**SHAW HOFSTRA +
ASSOCIATES**

Permit No: PRCOM20254503
Project Title: FIVE FOUR
Project Address: 301 SW OLDHAM PKWY, LEES SUMMIT, MO 64081
Parcel
Number: 341223 Location / Legal Description:
Type of Work: NEW COMMERCIAL
Occupancy Group: ASSEMBLY FOR FOOD AND DRINK INC BARS, RESTAURANTS, BANQUET
HALLS
Description: FIVE FOUR - NEW RESTAURANT WITH SITE PLAN INCLUDING PICKLE
BALL COURTS, BAG TOSS AREA, AND PARKING

PLAN REVIEW CONDITIONS & RESPONSES

NinetyFive
340

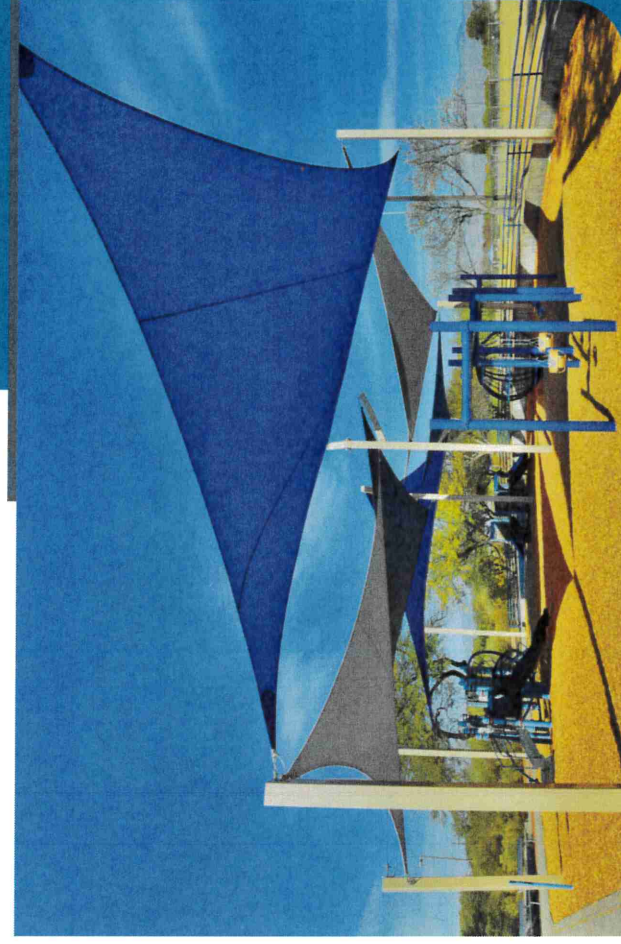
Action required: Provide verification that sail shades are minimum Class C per Table 1501.1. Footnotes a, b, & c have been omitted per Code of Ordinances Sec. 7-224.

Response: Attached **Sheet A009**, Sail Shades & Bocce Ball, has revised information on the sail shades. Shades are Commercial Ninety Five 340 with ASTM Standards, ASTM E84, 19B, Class A. Attached is Specification information from Commercial Ninety Five 340 with information showing Class A

ASTM E84 19B Class A
